We considered the traffic engineering aspects of this project and are more than a little surprised at the limited area that was studied for the largest intermodal in the southern hemisphere.

The M5-Moorebank interchange is the most important intersection for the largest intermodal terminal in the southern hemisphere – and it was done inadequately.

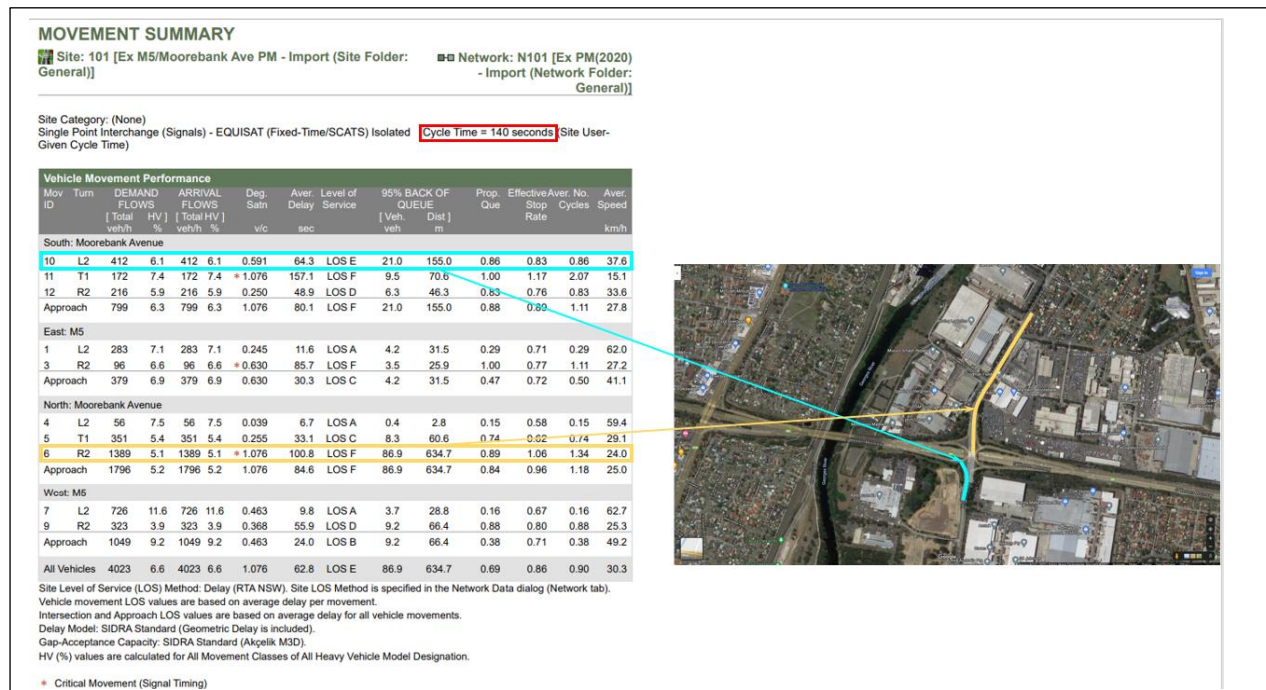
Consider the PM flows in the base year, which for convenience is reproduced below. The location map shows the intersection. The expected queue lengths for both the northbound and southbound movements have also been pencilled in.

The first impression is that the cycle time of 140 seconds is highly unlikely to be accepted by the TfNSW. The traffic engineers would certainly be happier with a smaller cycle time,

If we were to look at the flows from

- South: Moorebank Av – L2 movement (412) and
- North: Moorebank Av – R2 movement (1389)

Combined: $412 + 1,389 = 1,801$ vehicles

This compares to SIDRA's capacity of "Exit short lane" and "Merge lane" of 1,800.

The modelled 1,801 vehicles are at the maximum limit of SIDRA's short/merge lane capacity for the M5 on-ramp.

The next observation is that this maximum limit joins the M5 Motorway. Some will travel to the Hume Highway, but most will merge with the M5 Motorway traffic.

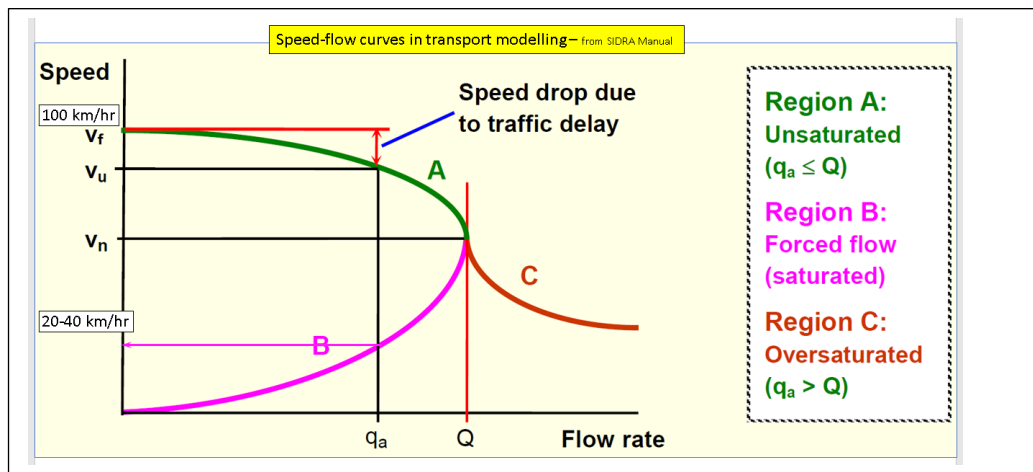
If we only know the Flow rate, say q_a , from the graph, the speed could either be on the green line, (Region A, Unsaturated) or on the pink line (Region B, Forced Flow, with a much slower speed, because of congestion).

From the community survey the speed in Lane 1 (where this traffic must merge) is about 20km/hr – 40 km/hr. This indicates the traffic on the M5, flows in Region B “Forced Flow” – pink curve.

- intuitively, most of the 1,801 vehicles must merge into traffic that moves at 20km/hr – 40 km/hr.
- traffic in the Forced Flow region has a high traffic density. A condition that is characterised by vehicles travelling close together and there are long delays and very long queues.
- In this case, those long queues will spill back into the M5-Moorebank Av interchange.

Therefore, it is most **unlikely**, that the M5-Moorebank Av interchange operates at Level of Service B.

Like all modelling software packages, the basic assumption is that traffic flows in Region A – indicated by the green line. This is also the case with SIDRA.

Much more work needs to be done to model traffic in Region B. If that were the case, the modelling would correctly show the performance of the M5-Moorebank interchange impacted by the M5 merge spill-back queue.
